August 26, 2014
Planning and Economic Development Board
155 Village Street
Medway, MA 02053

Public Hearing Continuation - Tri-Valley Commons Site Plan:

**Re: Tri Valley Commons
72 Main Street
Site Plan Review
Medway, Massachusetts**

Re: **Tri-Valley Commons Site Plan**

EXISTING CONDITIONS
 JOHN'S AUTO BODY, INC.
 25 JAYAR ROAD
 MEDWAY, MA

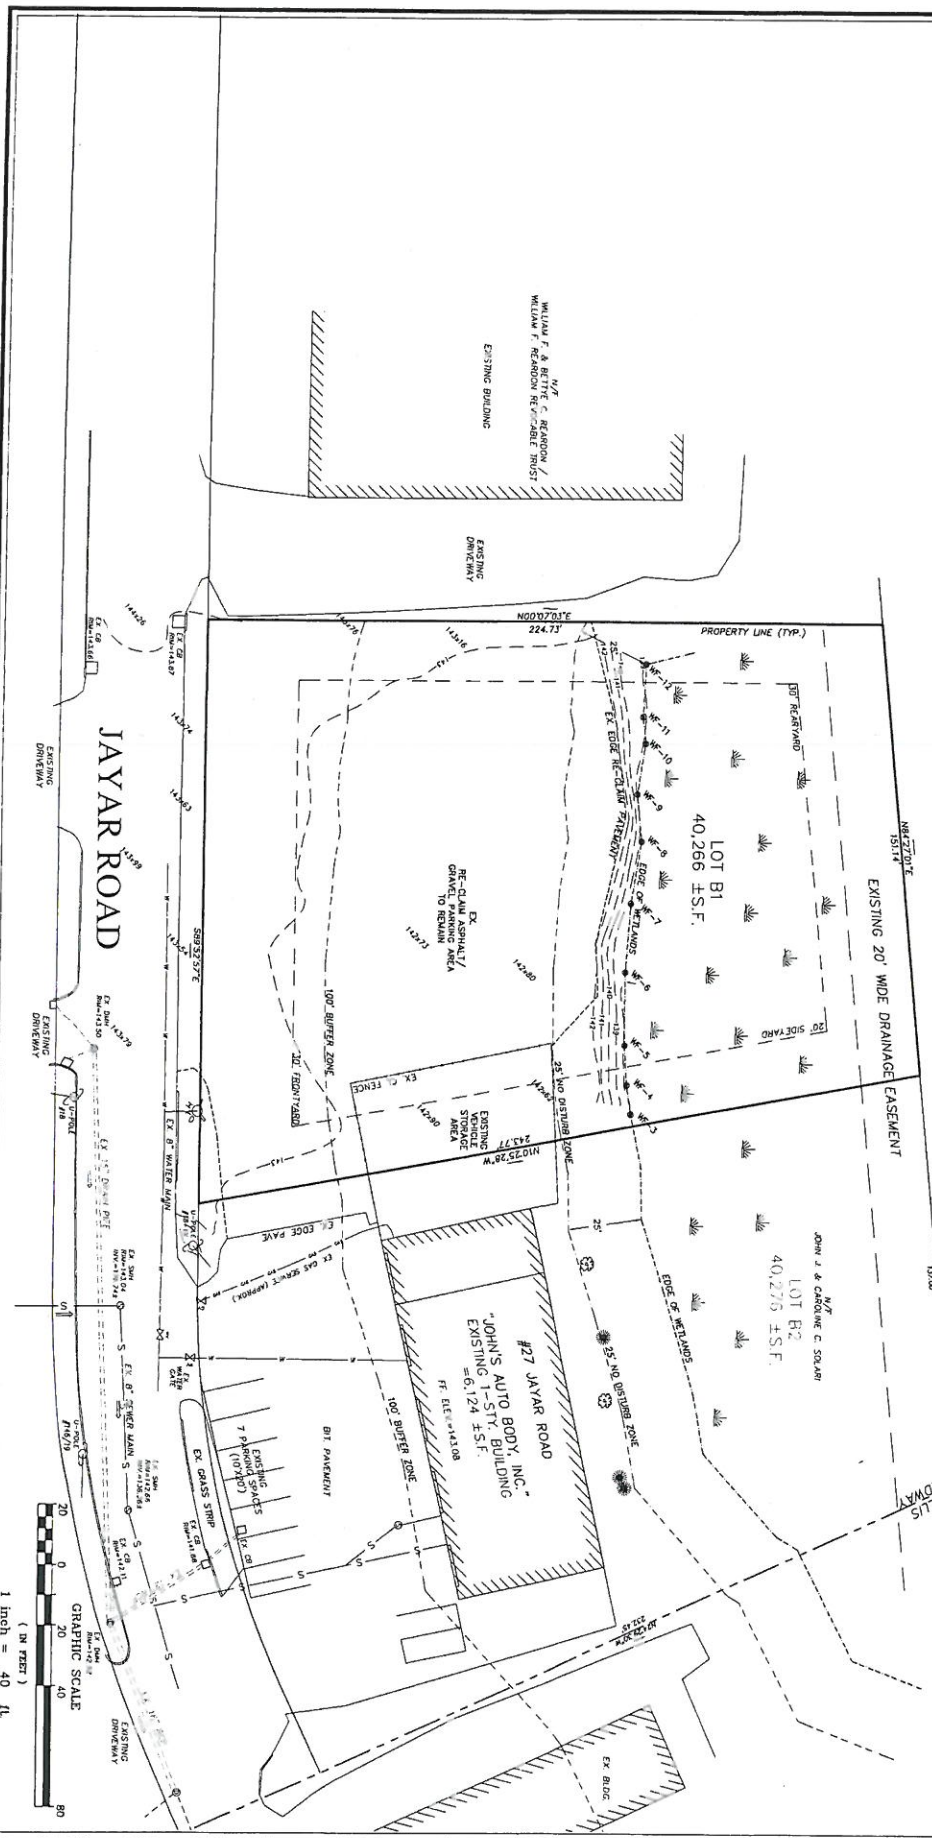
In regards to parking, the zoning regulations state that with four employees, there would need to be seven spaces. They can move spaces if necessary. If the handicap space is too close to the required setback, a waiver would need to be sought. In the past application, there was a waiver from the site plan regulations. The Board does not think there is a problem waiving the parking based on the existing parking on site.

There will also need to be a stormwater operation and maintenance plan in place. There should be a water quality unit in case of a spill. It is like a gas trap.

This may need a Special Permit from the Zoning Board of Appeals to address the mitigation to prevent the seepage into the ground. This should be filed before the site plan. The property is in the groundwater protection area. The Consultant indicated that this will probably need to be paved.

The Board recommended that the applicant show an elevation view, landscaping and lighting. The lighting will only be building mounted. The Board would also like more information about traffic movement between the two sites.

FRONT ELEVATION
SCALE 1/8" = 1'-0"

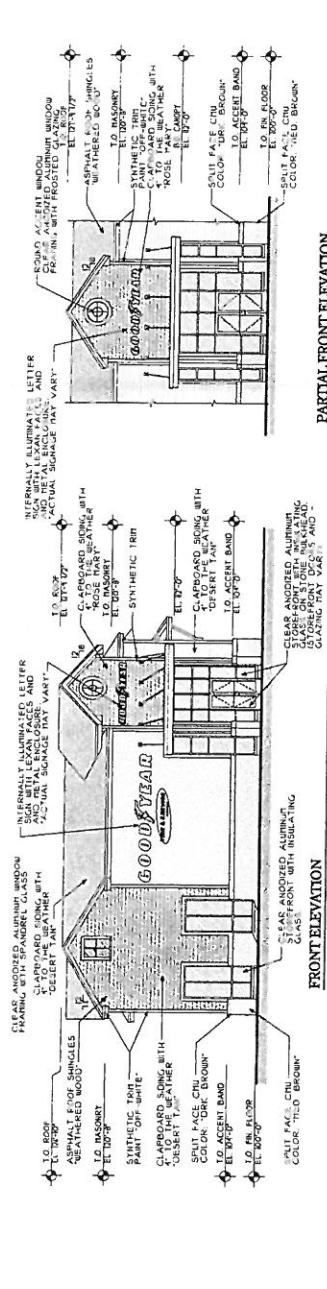
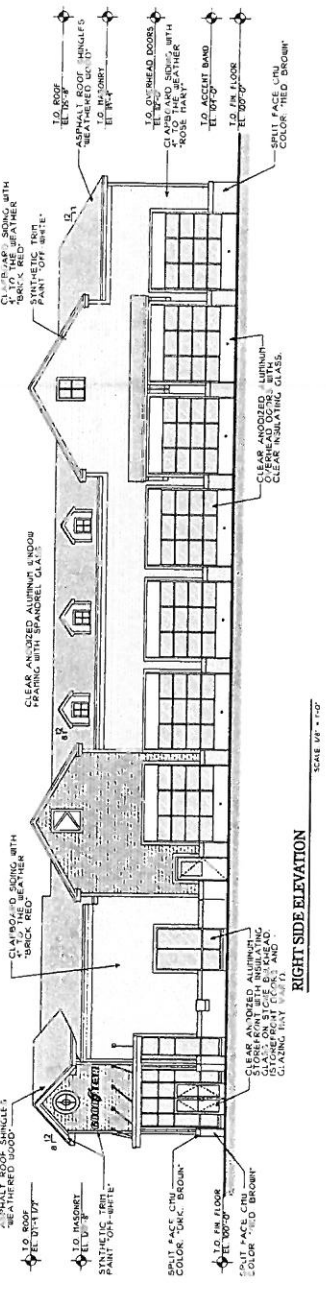
Signage for Goodyear was discussed. The scale is compliant with the sign regulations. The building elevation drawings that the Board was presented with were not the drawings presented at the previous Design Review Committee meeting on August 18th. These new drawings will not go to DRC prior to their letter being provided to the PEDB. The DRC's letter will be prepared based on what they were provided at the last DRC meeting. The drawings were not ready at the last DRC meeting. Extra detail was added to the building and rooflines.

Member Spiller-Walsh noted that the previous plans did not resolve the bulleted list of items which the DRC had provided to Mr. Landry.

OWNER: MECOBA PROPERTIES, INC.
 70 MAIN STREET
 WASHINGTON, DC 20001
 APPLICANT: THURKLEN, LLC
 240 GREAT ROAD
 ACTON, MA 01720
 "TRI VALLEY COMMONS"
 "SITE LAYOUT"
 PLAN OF LAND
 IN
 MEDWAY, MA
 SCALE: 30 FEET TO 1" (1:360)
 DATE: MAY 20, 2014

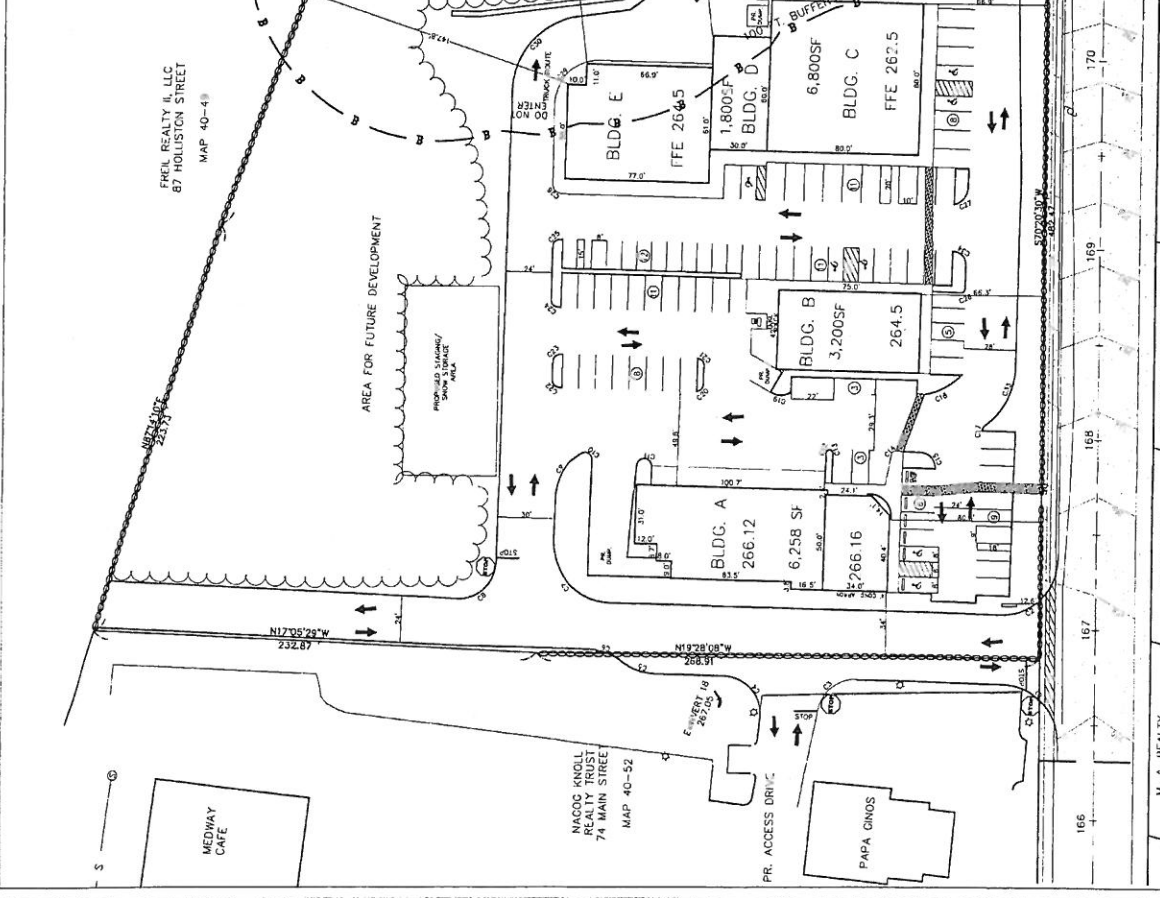
2. The plan proposes 142 parking spaces, including 11 van-accessible handicapped spaces. The plan includes a table illustrating how the number of spaces was calculated. The calculation indicates that 114 spaces are required. It indicates that 81 spaces are required for Phase I, and 90 are provided, and that 33 are required for Phase II and 52 are being provided. It should be noted that the calculations are based on net usable area. Since floor plans with spaces labeled were not provided, it is not possible to verify these figures.

7. Section 204-5 D (1) requires that dimensions of buildings and setbacks be on the plan. The dimensions of Building A were not entirely provided. The building is not regular and only two dimensions were shown for this building and not all setback distances were shown.

3. No response.
4. No response.
5. No response.
6. No response.
7. The Building A dimensions have been added to the plans.
8. All parking spaces have been dimensioned. A curb radii table has been added to Sheet 3.
9. No response
- 10 No response.
11. The sign design will be submitted at a future date.

"TRI VALLEY COMMONS"
 "SITE GRADING"
 PLAN OF LAND
 IN
 MEDWAY, MA
 SCALE: 30 FEET TO AN INCH
 DATE: MAY 20, 2014

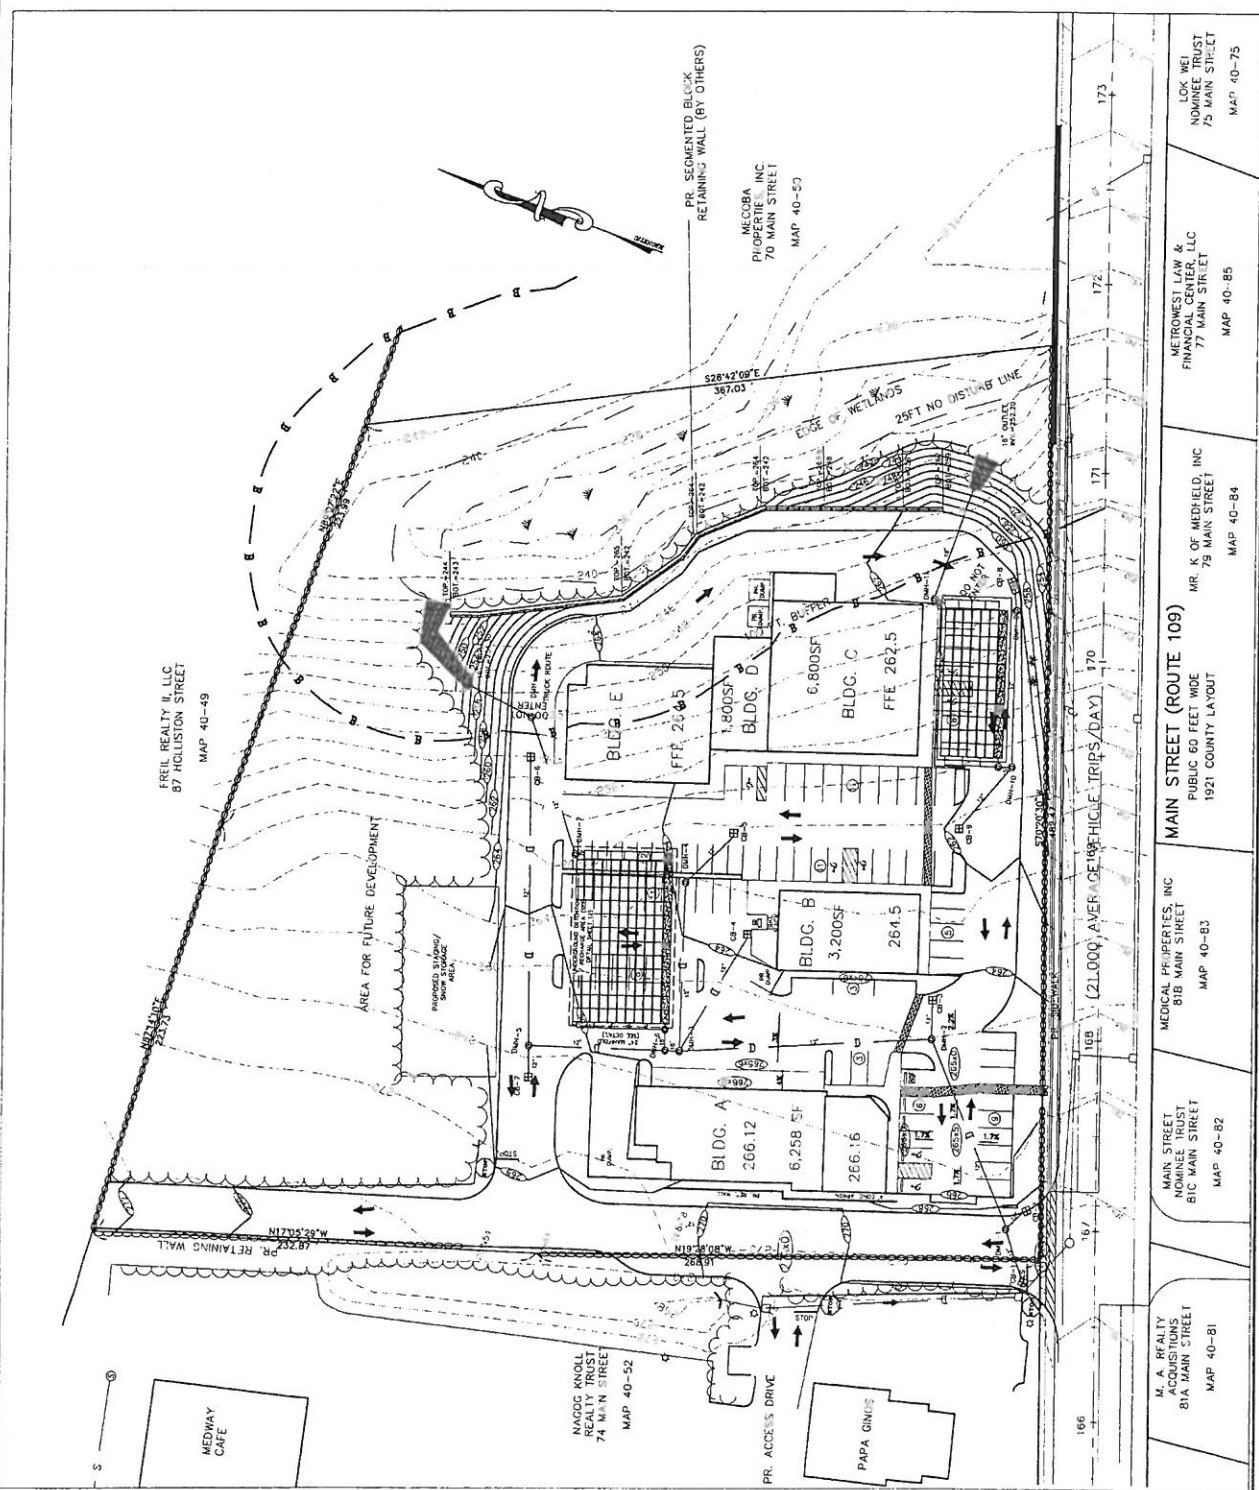
The roof drains are not shown on the plan. This needs to be placed on plan. A hard pipe connection is recommended. There will need to be a grease separator if there is going to be a restaurant on site. This is a plumbing issue and this will go into the sewer.

- 17) Are all of the sidewalks on the site proposed to be cement concrete?
- 18) The Applicant shall verify the siltation basket is also being used outside the property as well.
- 19) What type of pipe material is being used for the drain and gas line?
- 20) Are there electrical and communication lines provided to the building?
- 21) It may be beneficial to include the drainage infrastructure on the grading plan to help clarify where runoff will enter the system. It is difficult to review drainage infrastructure without grading.

21) The drainage structures have been added to the grading plan.
